# Conceptual Review Agenda

Schedule for 05/18/15 to 05/18/15

# 6617 S College Marijuana Cultivation Facility

**Re:** 6617 S College - Medical Marijuana and Cultivation Facility - Expansion

# NORTH ELEVATION

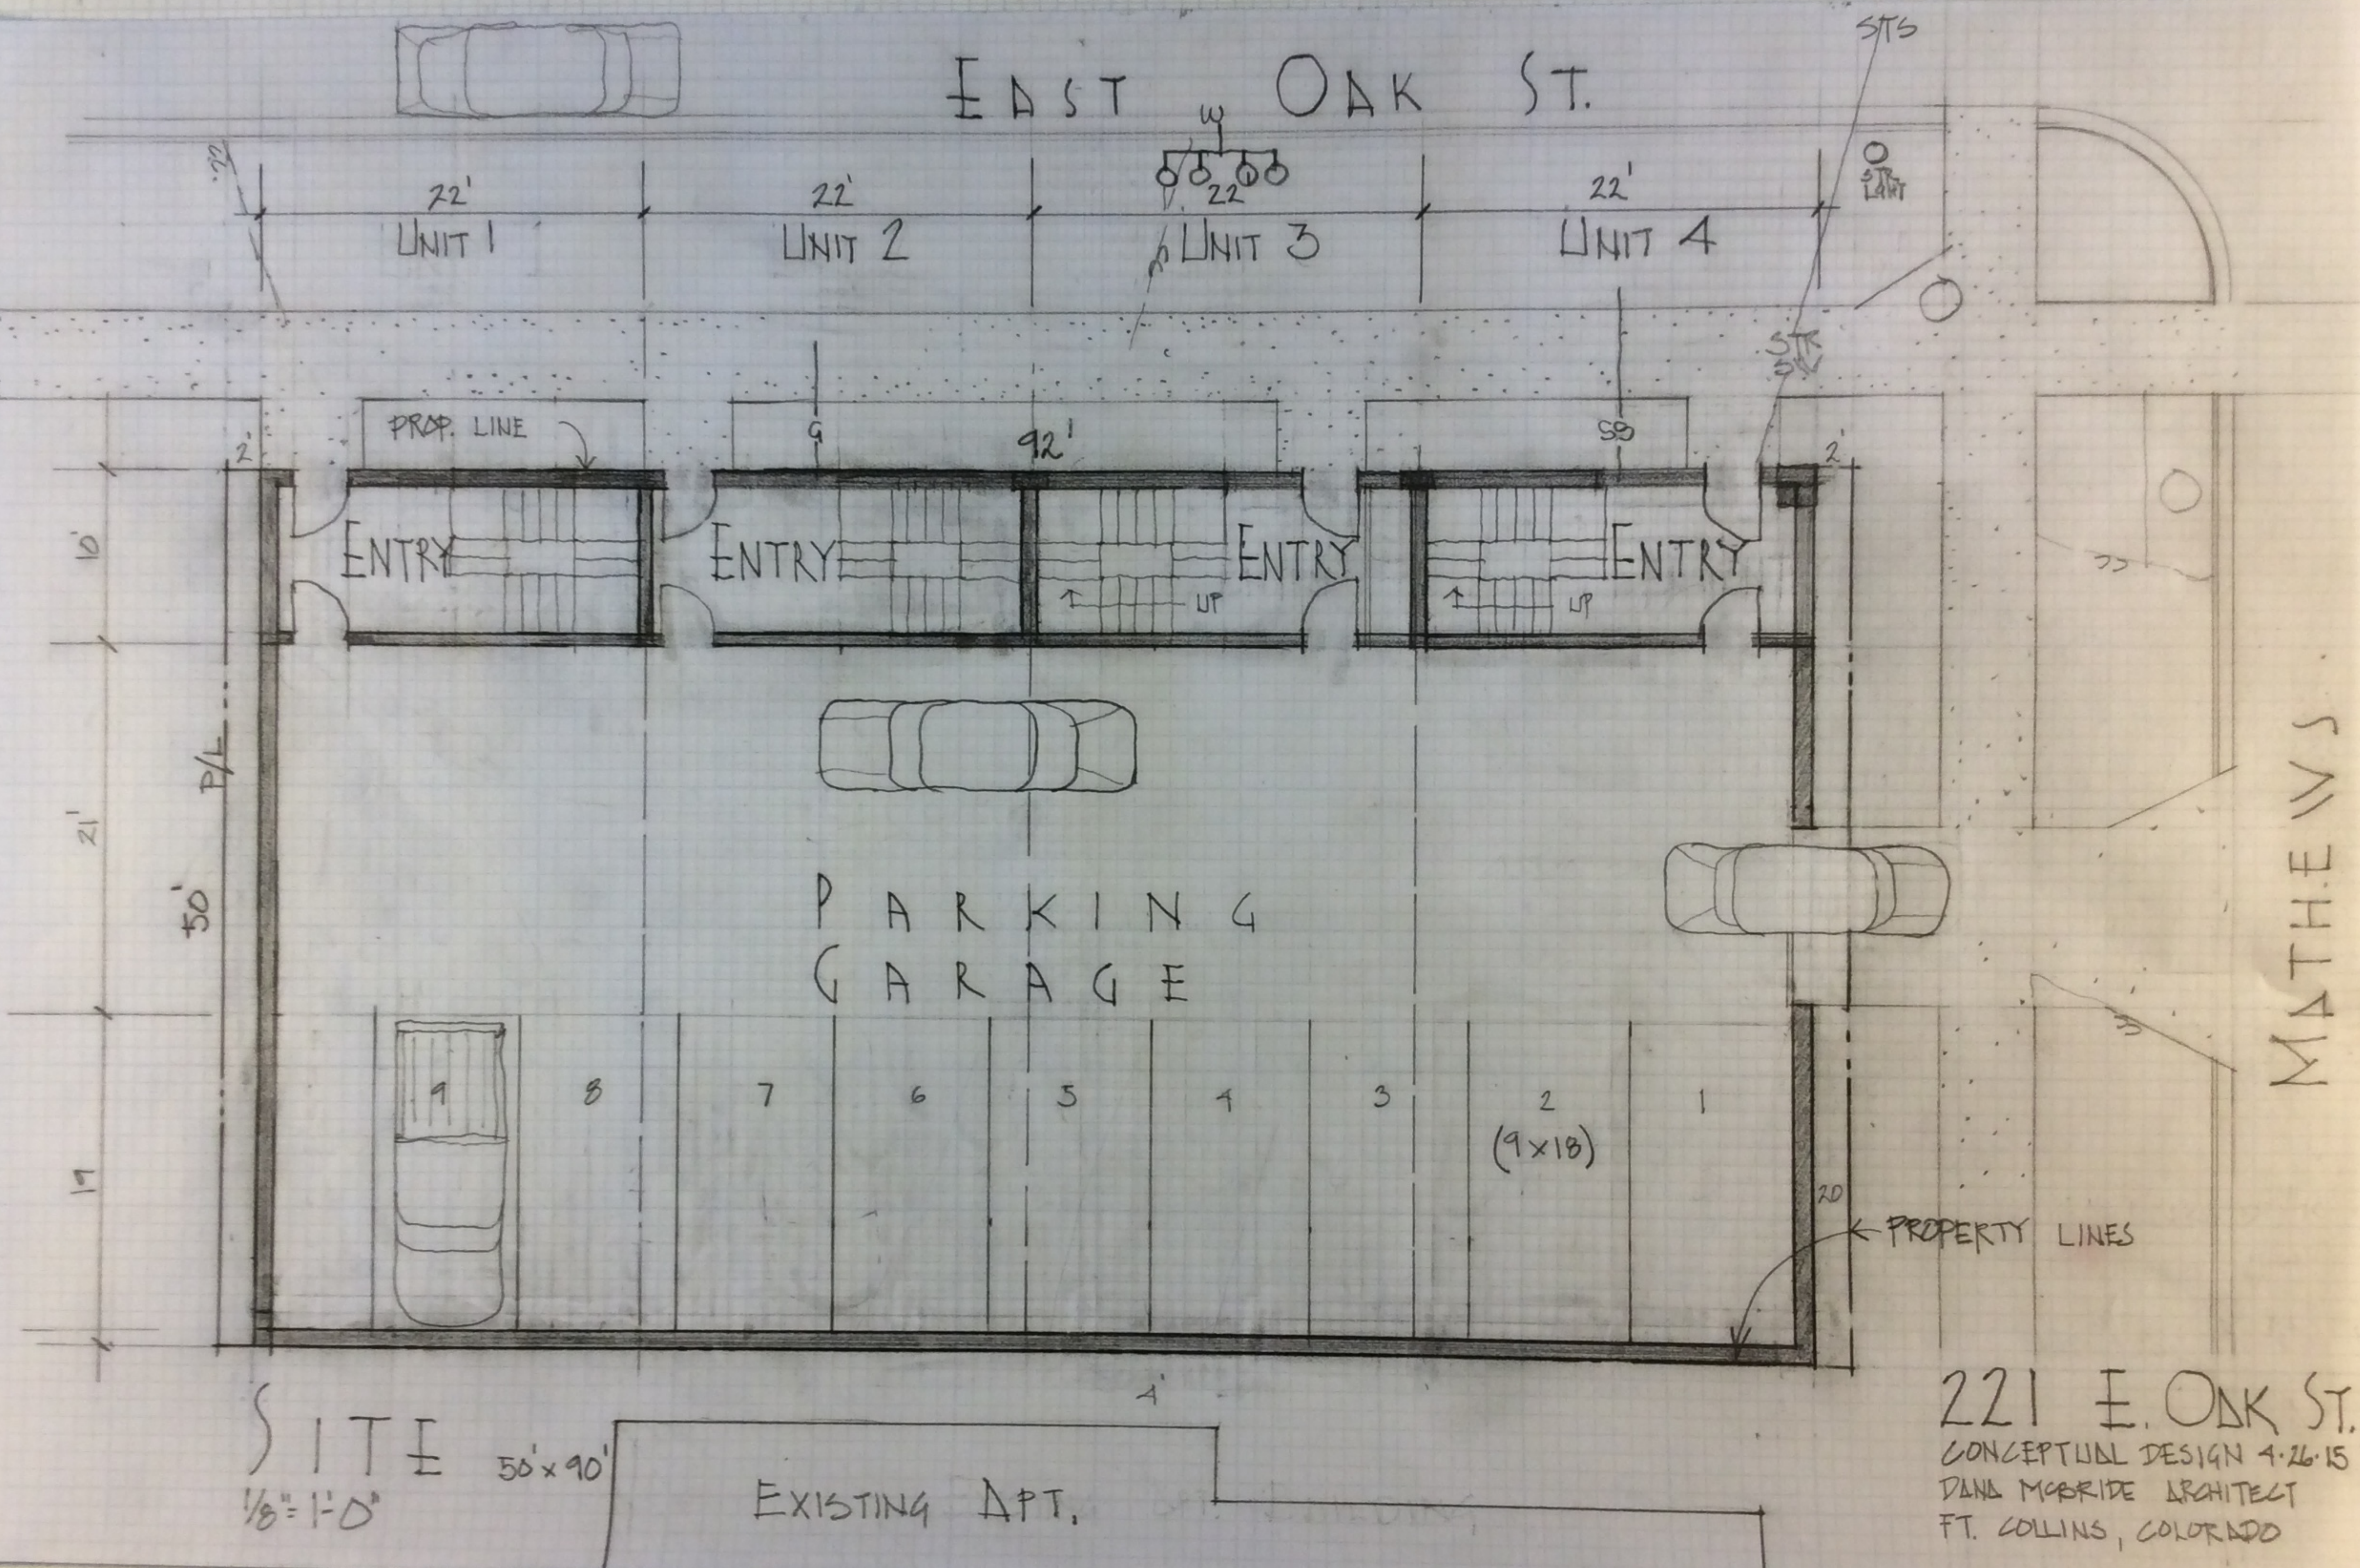
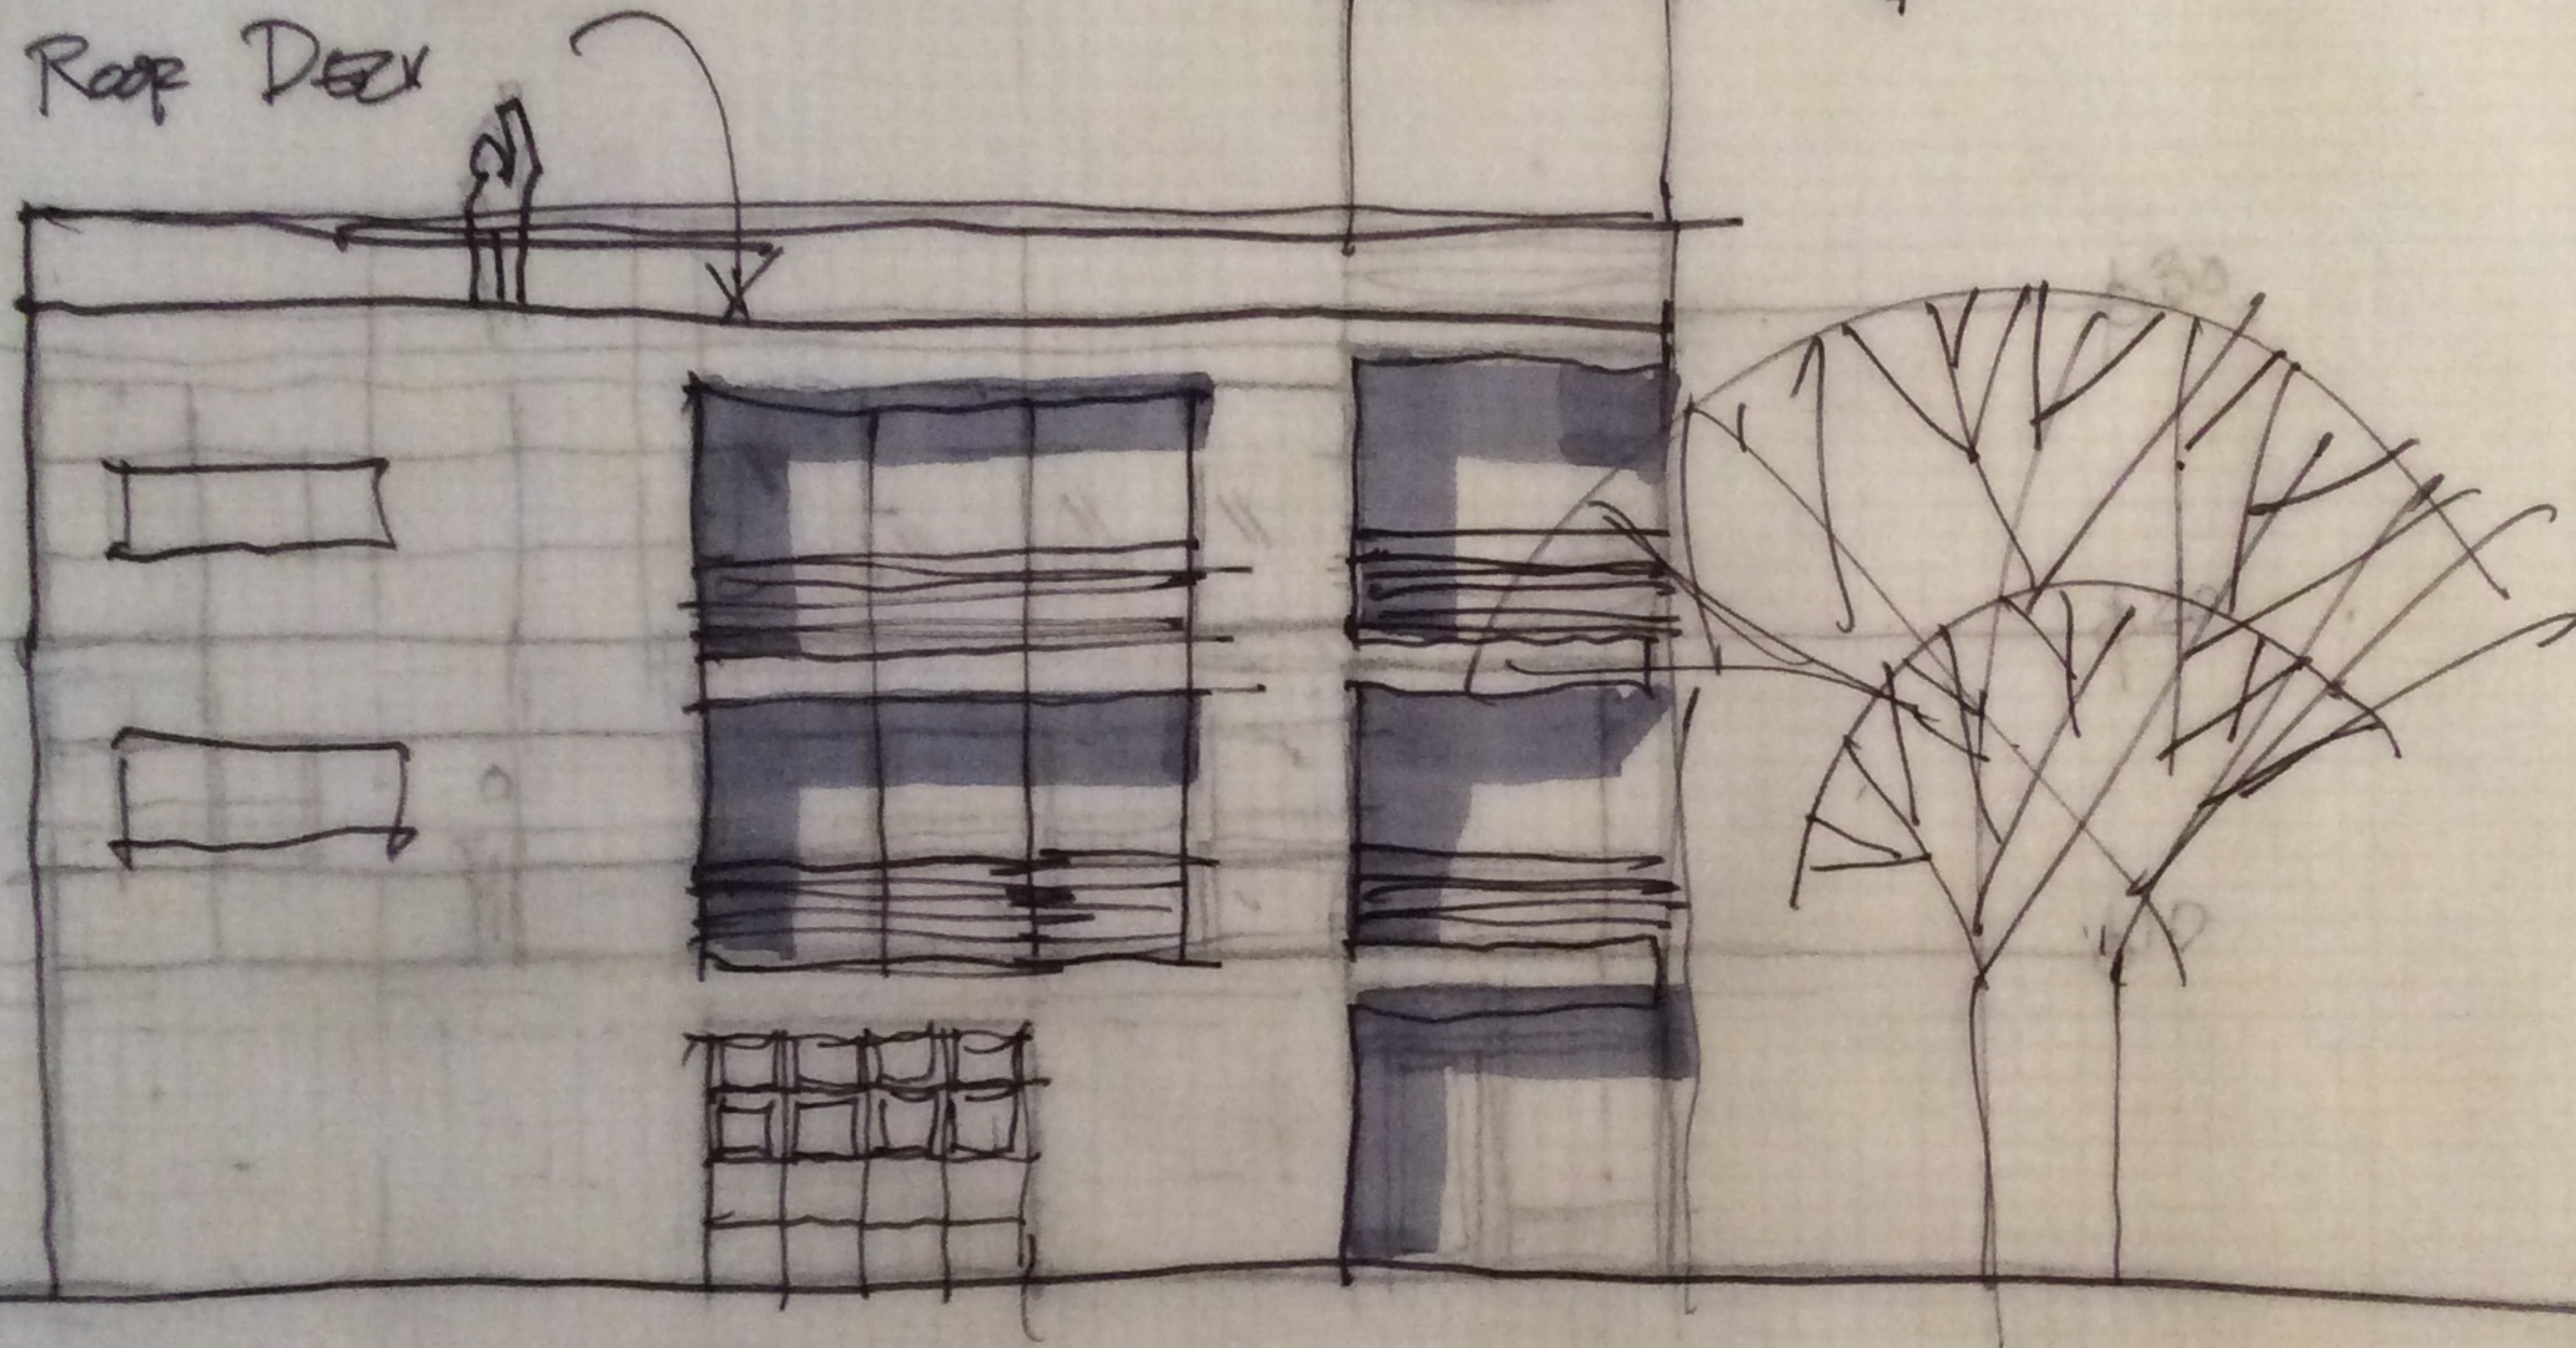
4. In order to adequately review for compliance with LUC 3.4.7, please submit cross sections, perspectives (including from the street level), and contextual elevations, with measurements, showing the proposed building in relation to the other buildings on both the MAtthews and Oak Street blockfaces. Also, please provide color photographs of the buildings on either side of this project.

ROOF PLAN

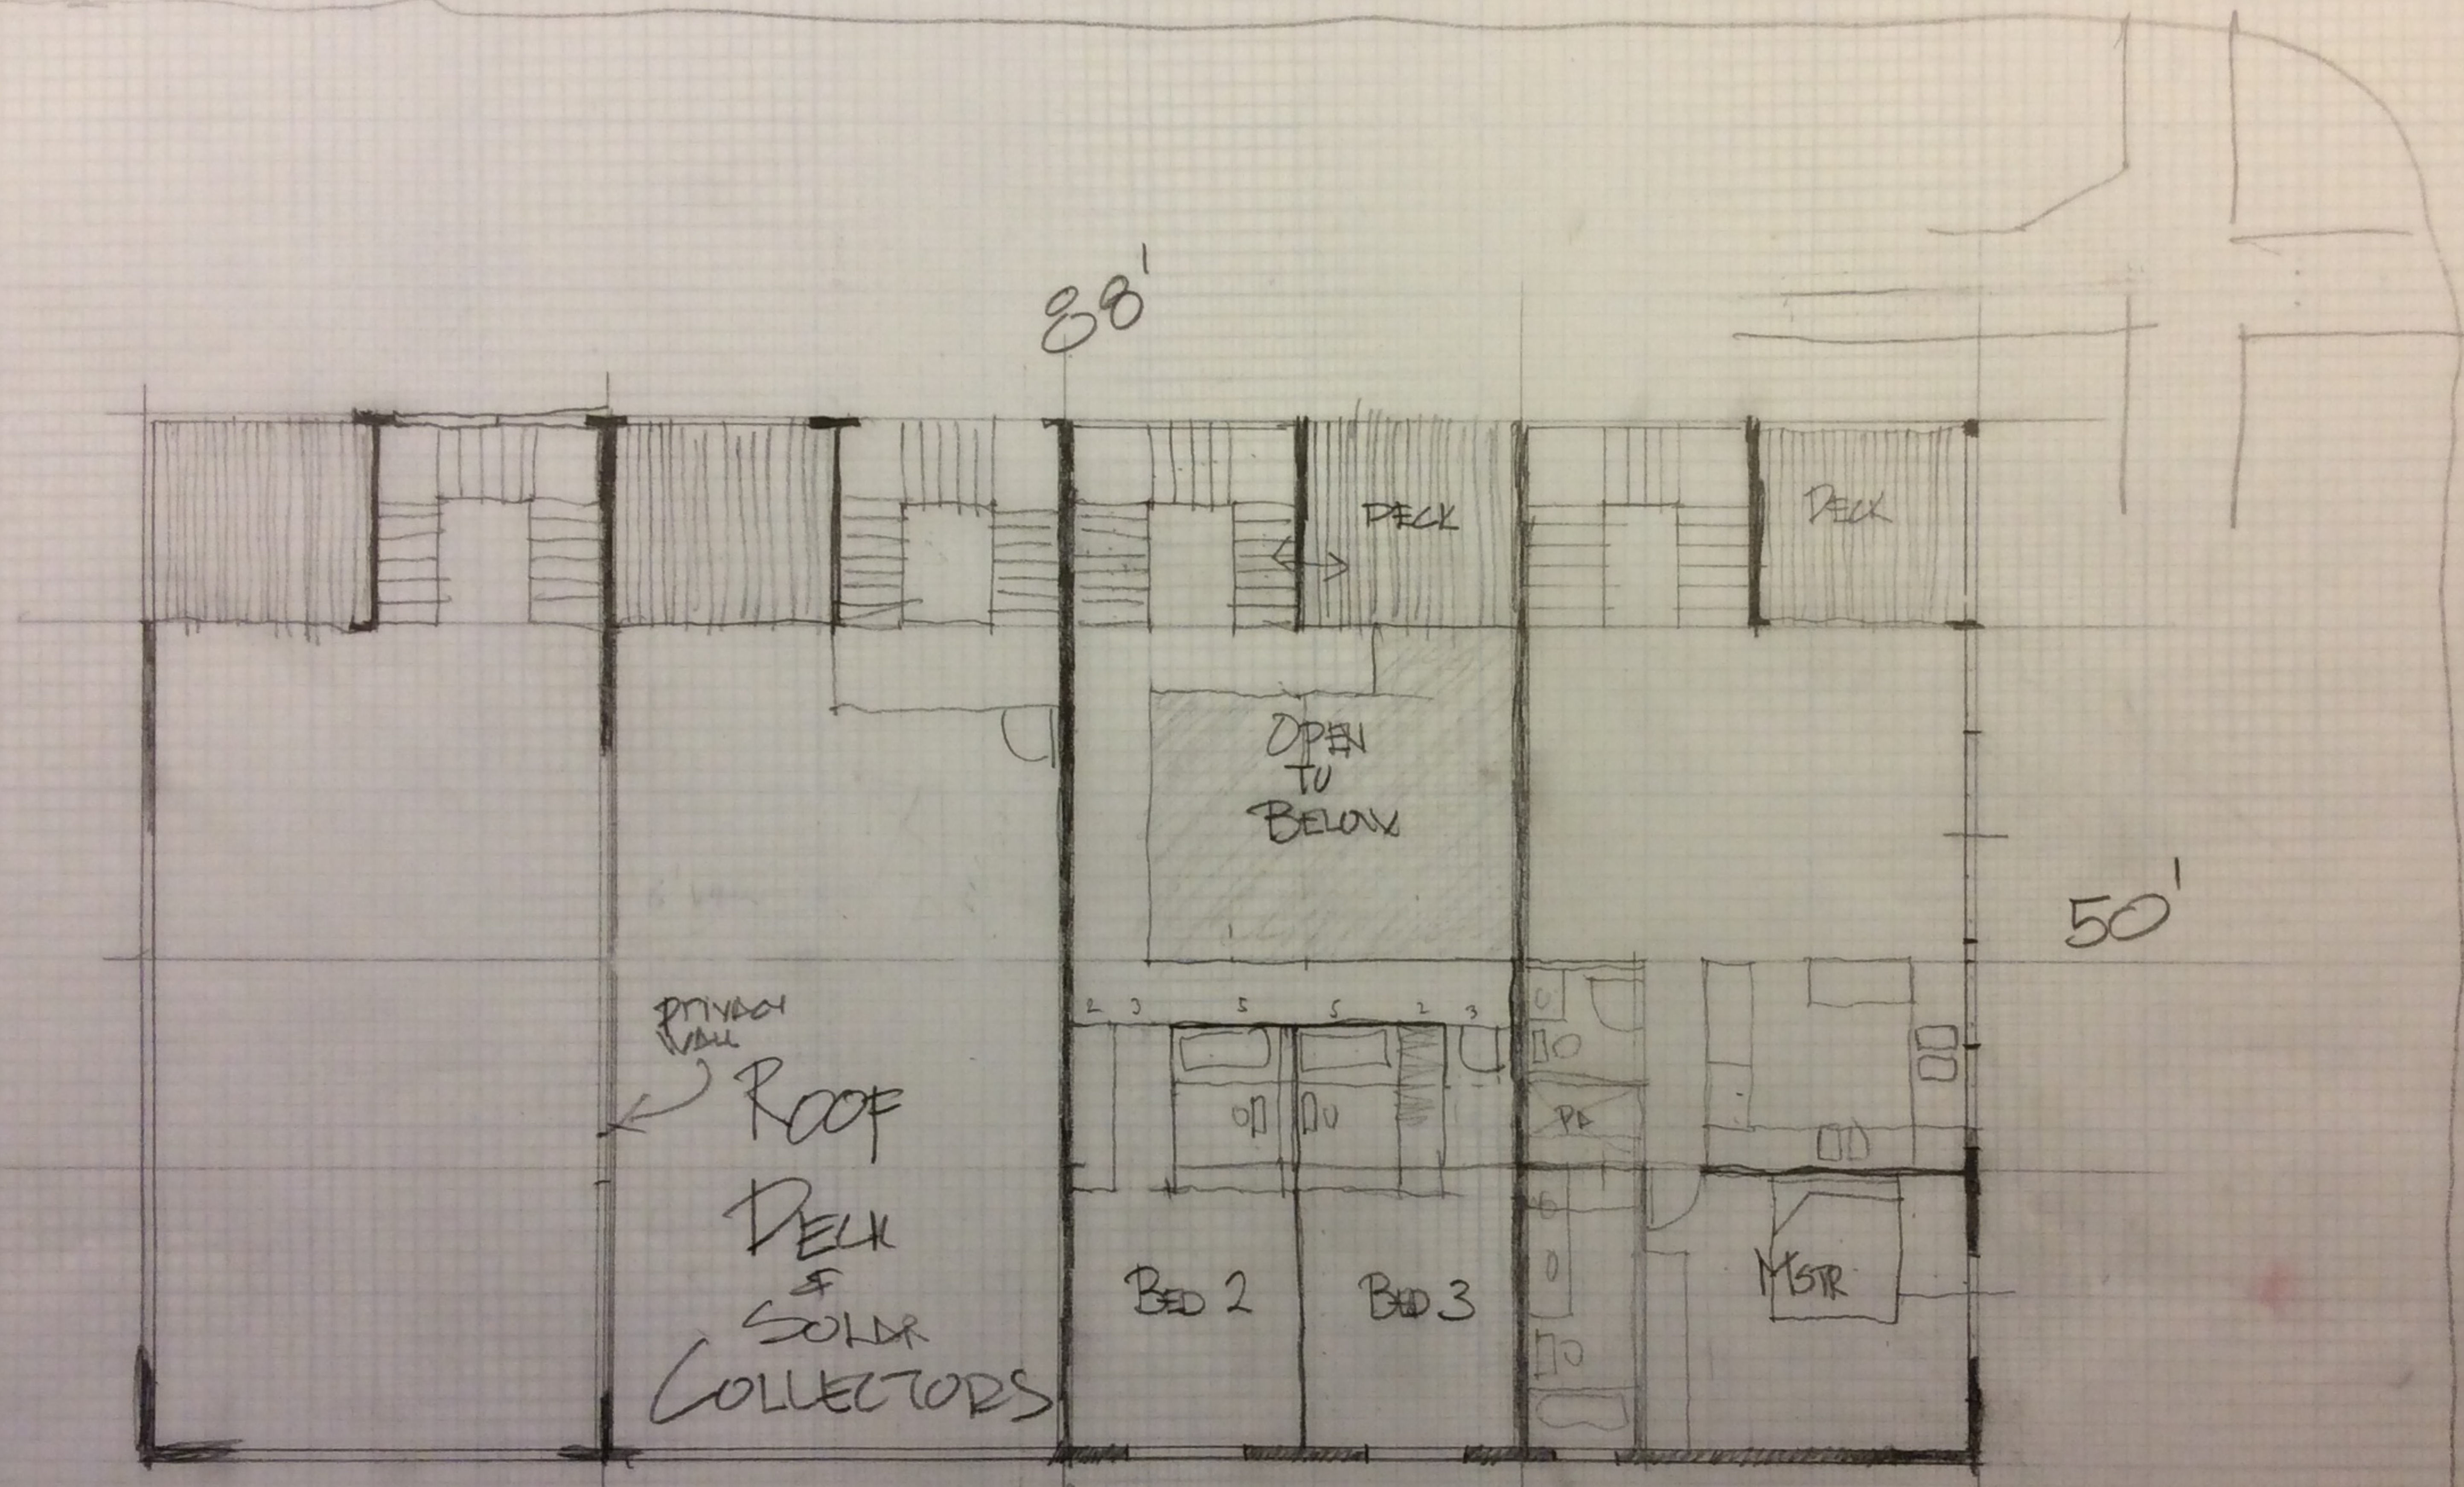
1. The maximum floor area for this project will be equal to the square footage of your lot per Land Use Code 4.9(D)(1). The floor area shown on the site plan is above this threshold. You will need to seek a modification to this standard if you wish to exceed the maximum floor area.
2. You will need to provide a trash and recycling enclosure per Land Use Code section 3.2.5.
3. Per Land Use Code section 4.9(D)(5), the allowable floor area on the rear half of a lot shall not exceed thirty-three (33) percent of the area of the rear fifty (50) percent of the lot. The proposed building will exceed this limit. You will need to seek a modification to this standard.
4. The following setbacks will apply to this project. The proposal does not meet any of these setback requirements. You will need to request a modification to each of these standards:
